N4906B-01A-S

SERVICE NOTE

N4906B - Serial BERT

Situation:

Graphics Card

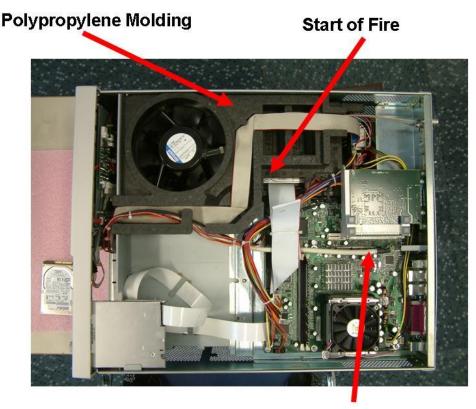
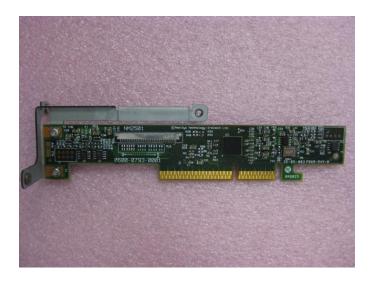
A surface-mount ceramic capacitor suffered physical stress during the manufacturing process, leading the capacitor to crack. During operation this crack placed stress on the internal structure of the capacitor, and caused the plates to short together. (The plates are separated by very little space, made up of very thin insulators.) This caused the capacitor to have very low residual impedance, resulting in a very high current conducted through the capacitor and the 12V path on the motherboard for some period of time. The low impedance didn't lead to a current high enough for blowing the fuse. Therefore the higher current was available long enough to create a very high temperature ($T > 300^{\circ}C$) The high temperature ignited the polyurethane molding used to conduct the airflow for cooling through the instrument.

The following photo illustrates the layout of the instrument. If shows the polypropylene molding, the graphics card and the starting point of the fire.

The countermeasure for this issue is to exchange the graphics cards. The new graphics cards are produced with an improved manufacturing process eliminating the risk of micro cracks. They either have an additional fusing to protect the 12V path or they have eliminated the 12V path altogether. The graphics card can be exchanged by Agilent authorized personnel only.

Motherboard still considered being good – no exchange required:

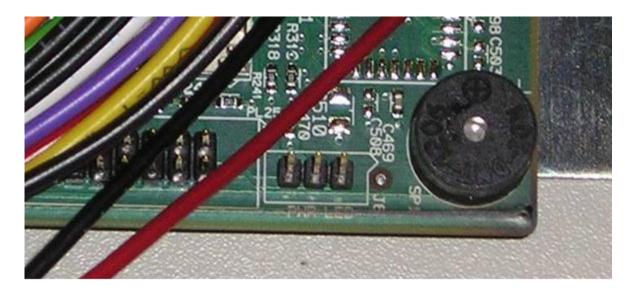
There might be discoloring on the PC motherboard in the shown corner (brown color). This can be ignored. The function or the quality of the motherboard is not affected by this.

Motherboard considered being bad – please exchange:

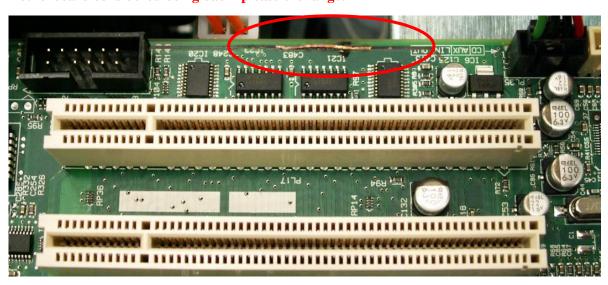
In very exceptional cases if you see traces of smoke or fire, the motherboard needs to be exchanged. In these cases typically the integrated display of the instrument would not work anymore. The exchange of the motherboards can only be done in the Service Center - onsite repair is not possible.

The following discoloring is intentional – no exchange required:

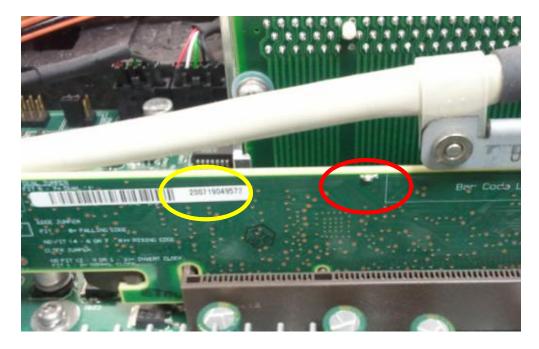
This effect is caused by an intentional sealing of a high impedance area to avoid issues in environments with a high degree of humidity. No exchange of the motherboard is required here.

Sample #1 (Revision NM2501):

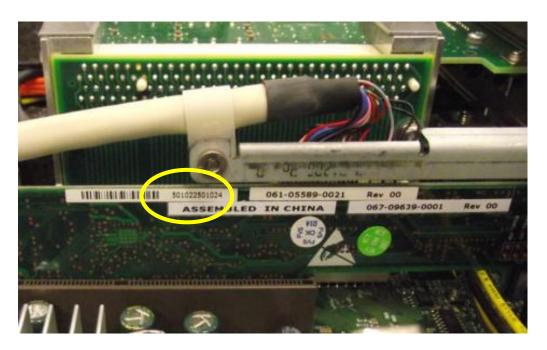
The board has a fuse on top (red circle) and a serial number (yellow circle) starting with 200... In the case above it is 200719049572)

find one of the 2, then the correct board is installed and the unit is safe and OK:
